SIB 46 01 22 TURN INDICATOR HOLDER LOOSE

2022-04-06

Model	Model Description
K63	S 1000 R

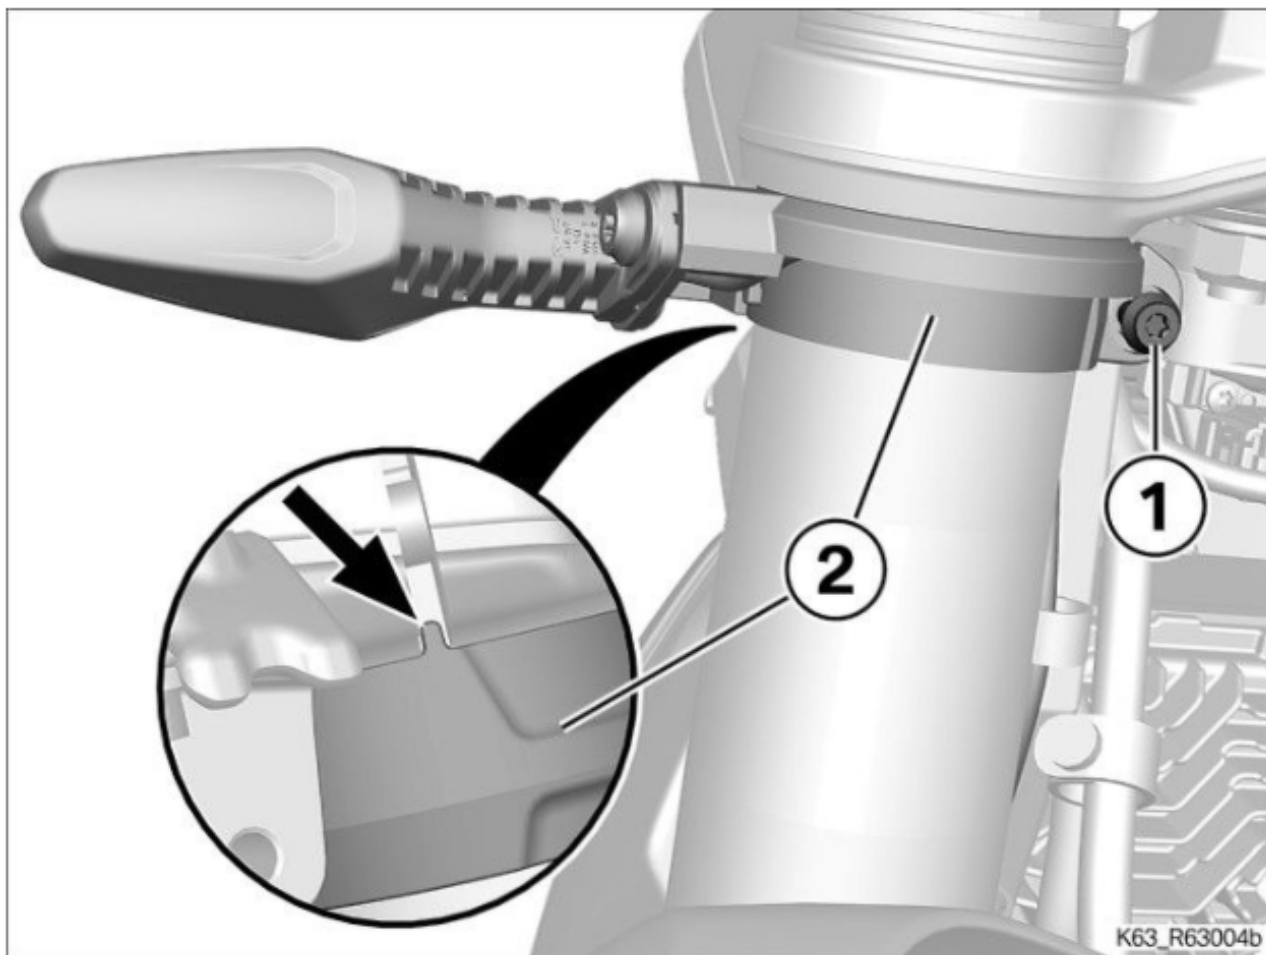
Over time, the turn indicator holders may become loose and shift away from their designated place on the fork tube.

The turn indicator holders remain loose on the fork tube even if screw is retightened.

Apply protective film to the fork tubes under the turn indicator holders.

46 51 8 560 150	VIN protective film	QTY: 4 per motorcycle
-----------------	---------------------	-----------------------
